City of Somerville

URBAN DESIGN COMMISSION

DESIGN REVIEW RECOMMENDATION

62 Prospect St: Civic Space

Central Plaza Design Evolution

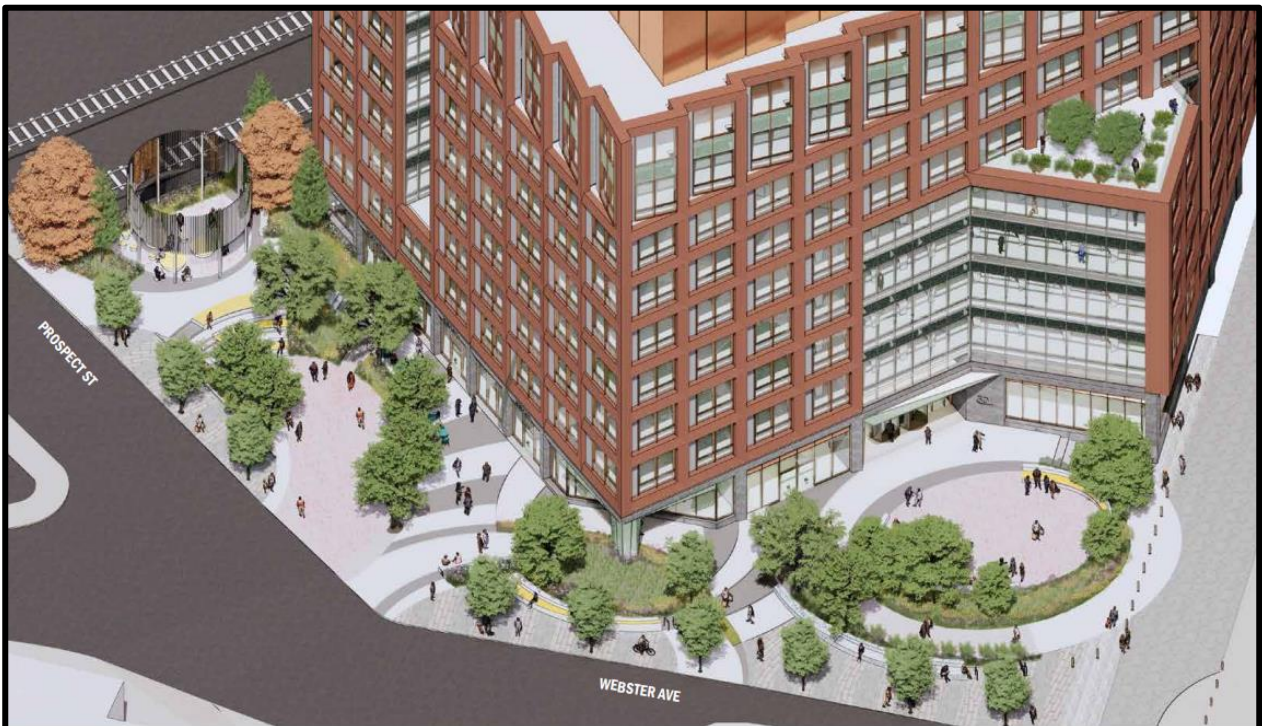
- Explore ways to incorporate more “fun” into the design concept, consider the use of color and other elements to help the space find its identity.
- Look for ways to incorporate “cut glass” into the park design to connect with the sites history of being a glass factory.
- More detail on the grading is needed to understand where there is a potential for a sloped walk vs. a ramp.
- Need more details on what the space will look like a night.
- Explore ways to reduce some of the hardscape so the space does not create a heat island effect.

- Space needs to be “funky and creative,” keep the weird moments in the design.
- Additional detail needed on “interactive feature” included at southern end of civic space. Applicant suggested a water feature could be included in the program element which was supported by the UDC.
- Look for ways to incorporate “wow” moments into the space, especially at the northern end of the park facing the GLX station and Union Square beyond. The

proposed pavilion could accomplish this if larger and more expressive. The Commission was also open to the exploration of other sculptural concepts to be included.

- Scale of pass through is too small to make both sides of the civic space feel connected, especially from northern end of civic space where grade is higher. Explore increasing the scale of this in coordination with the adjacent proposed lab building.
- Lighting of the civic space needs to be developed further to make space feel more welcoming and unique in Union Square neighborhood.
